ADDENDUM NO. 3

TO: PLANS AND SPECIFICATIONS FOR STATE OF MISSOURI

**Replace Boilers and Controls
Farmington Correctional Center
Farmington, Missouri
Project No.: C2006-01**

E6.0

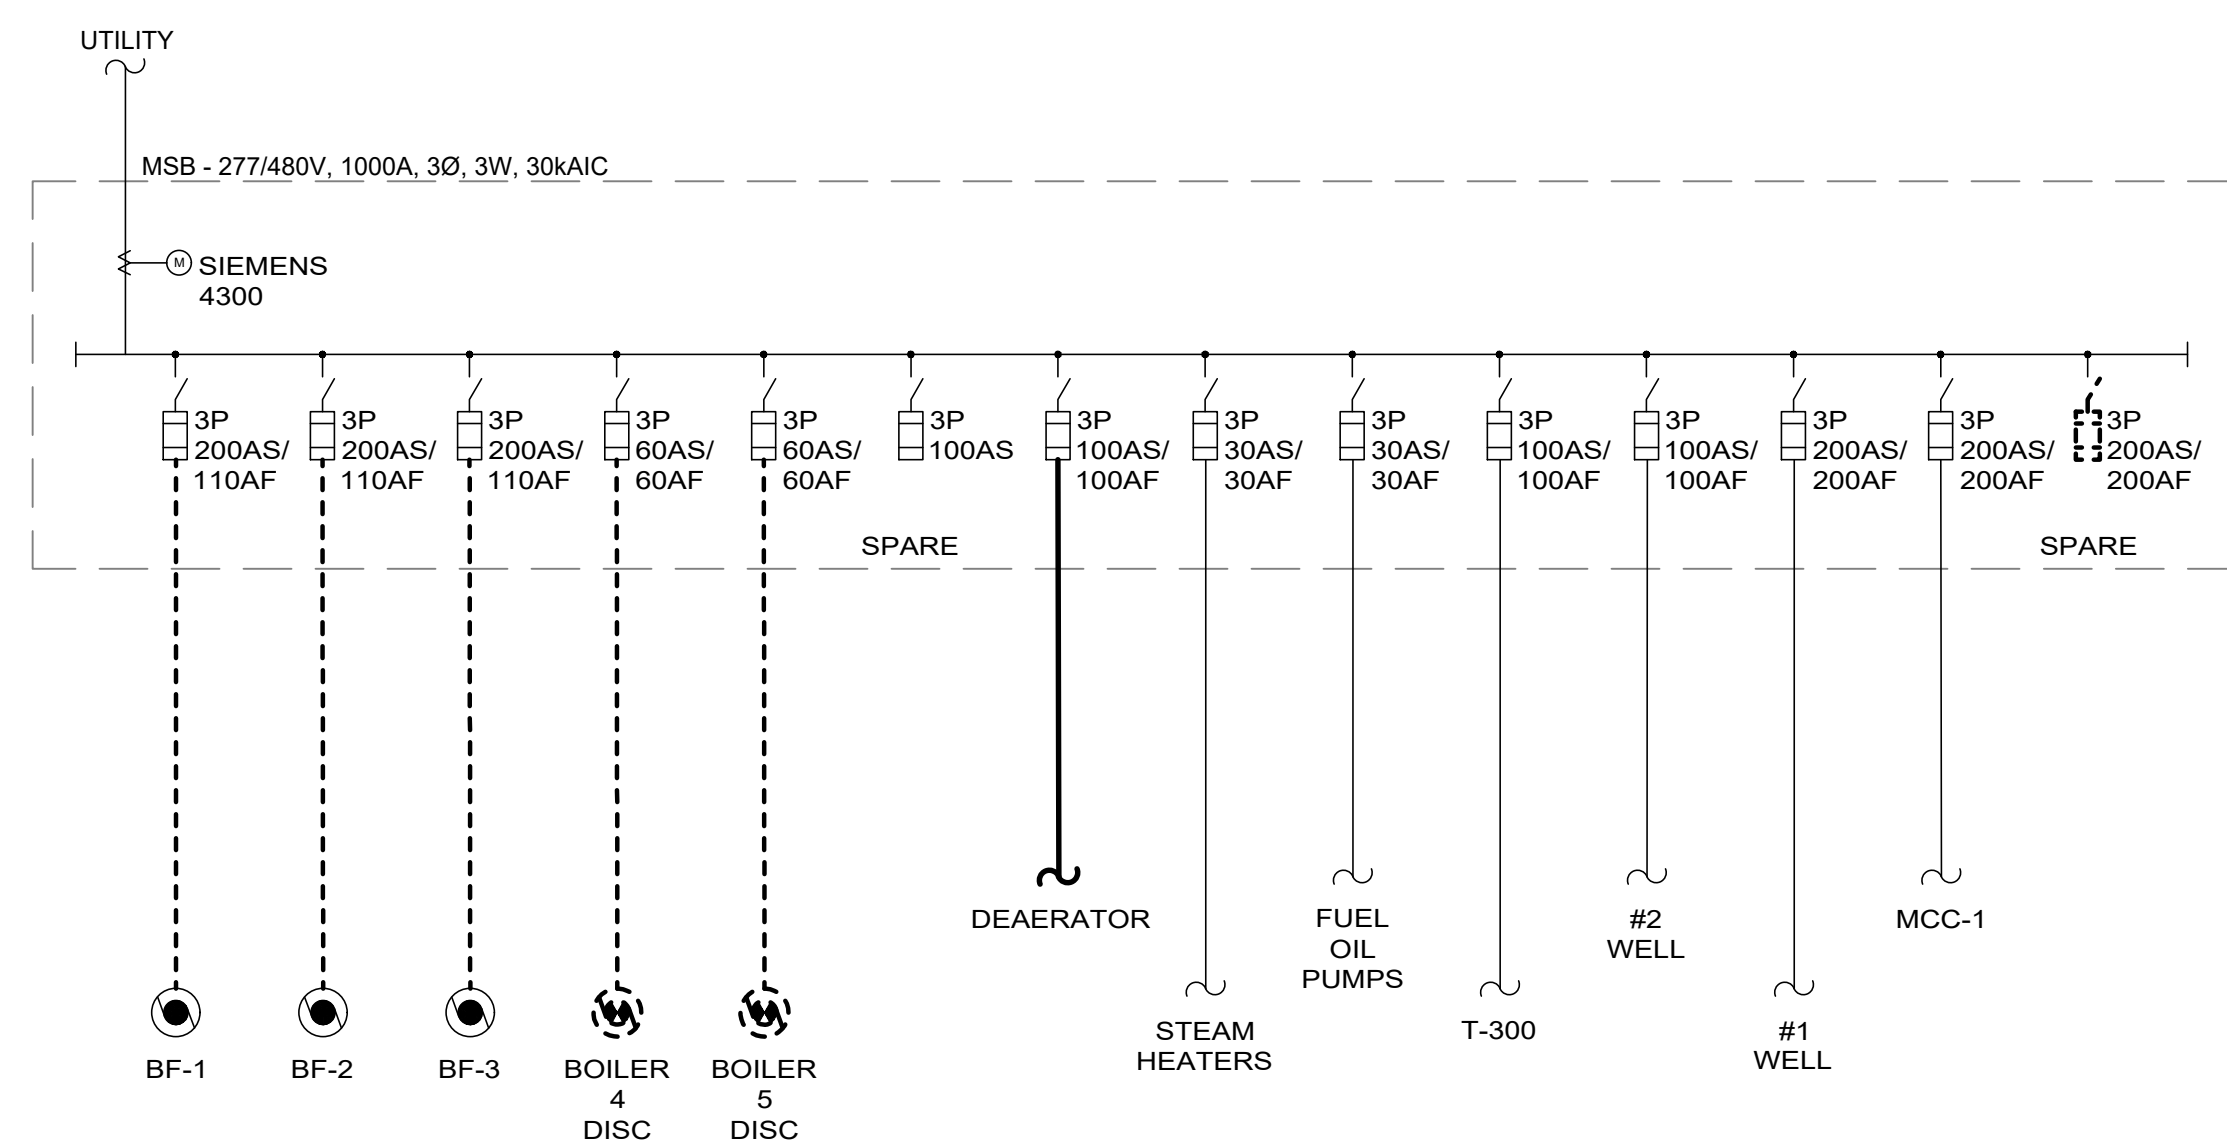
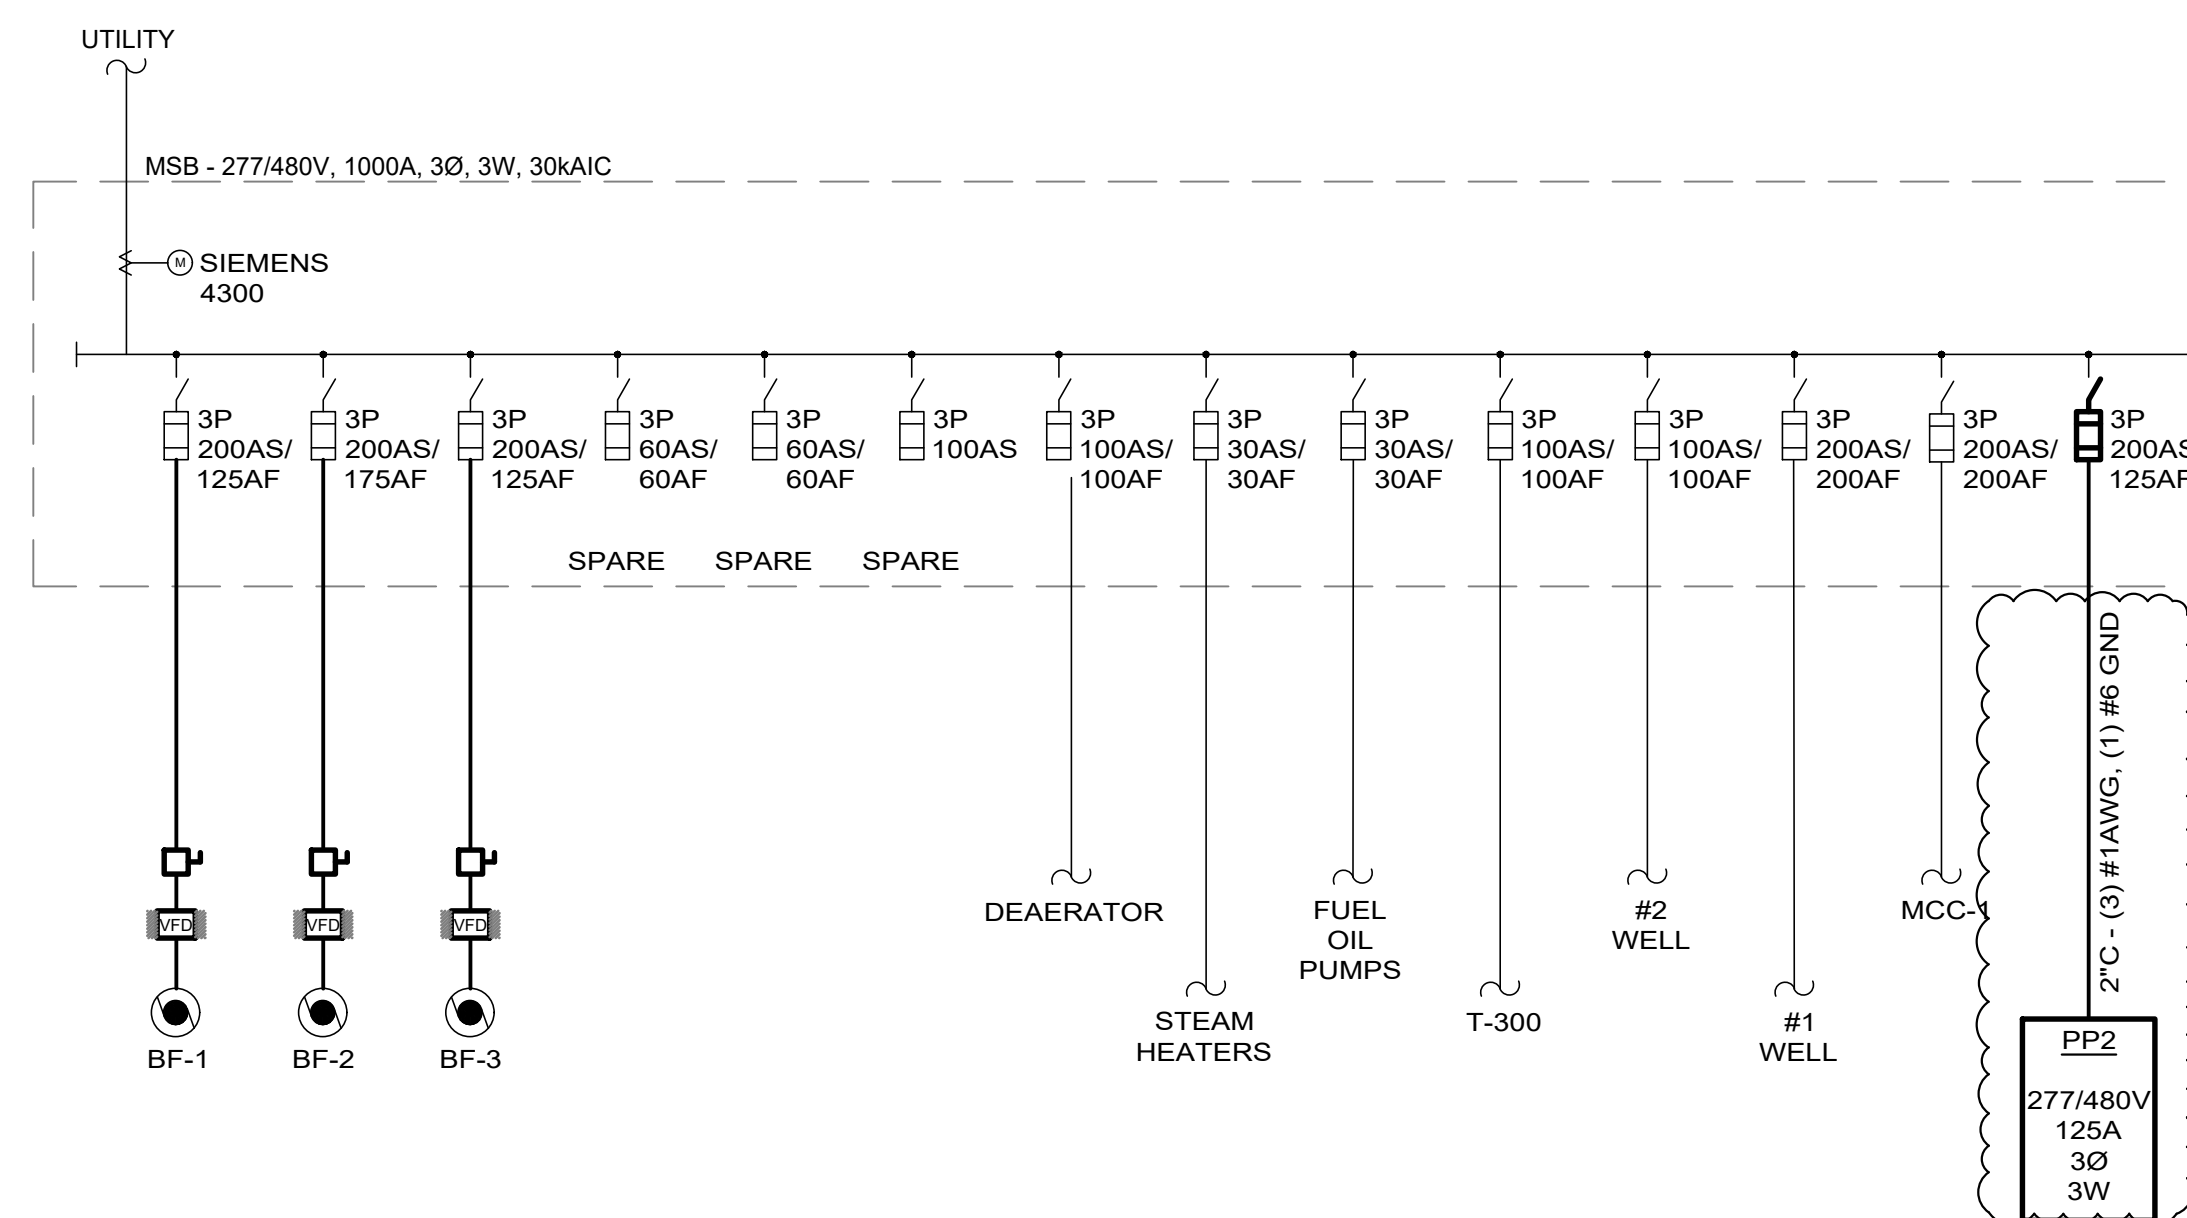
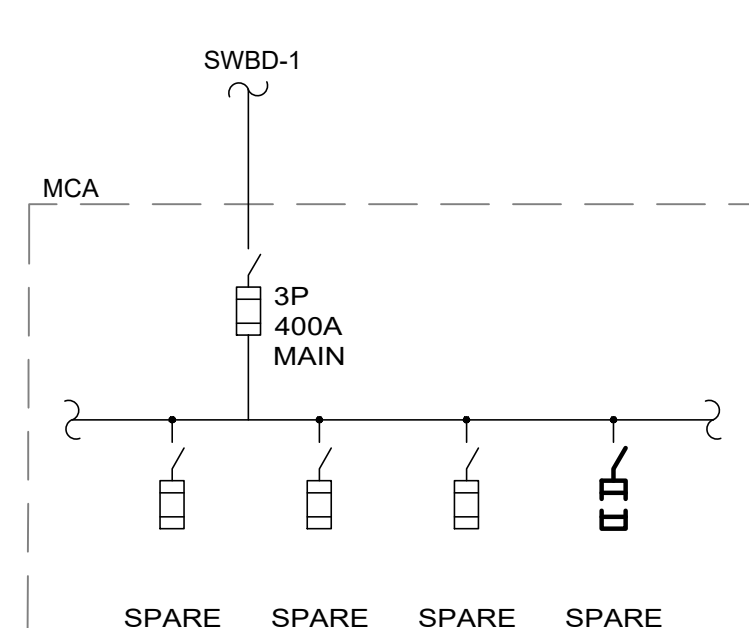
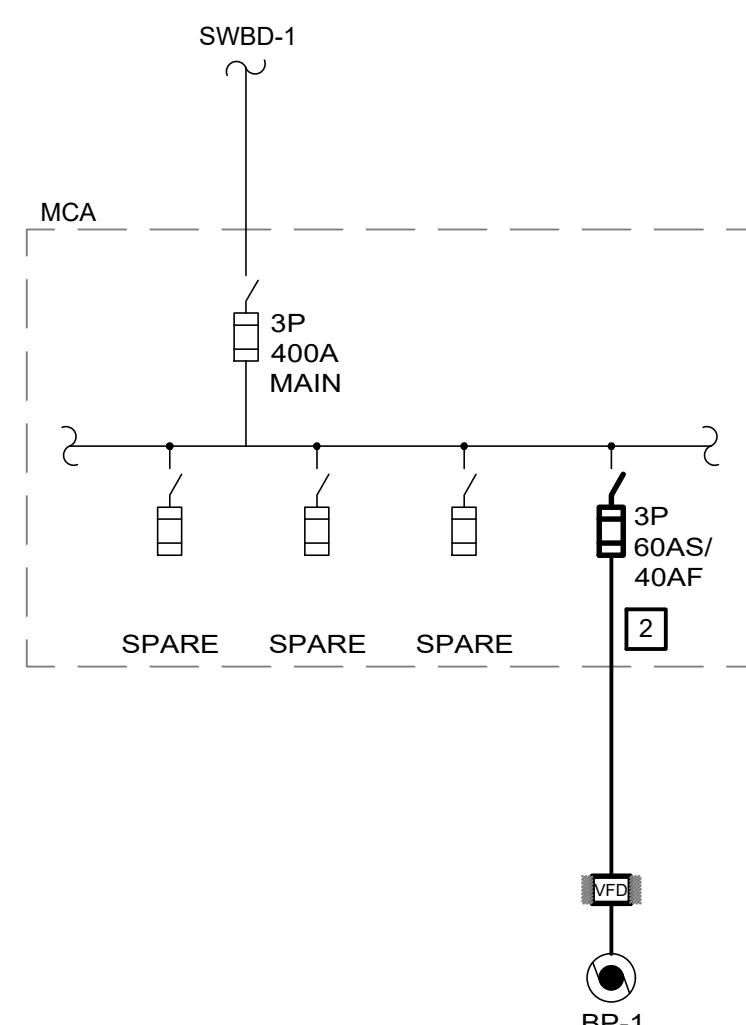
1. Volume 1 – Drawing E6.0 – Electrical One Line Diagram and Schedules
 - a. REVISE per attached Revision A, dated 9/6/2023
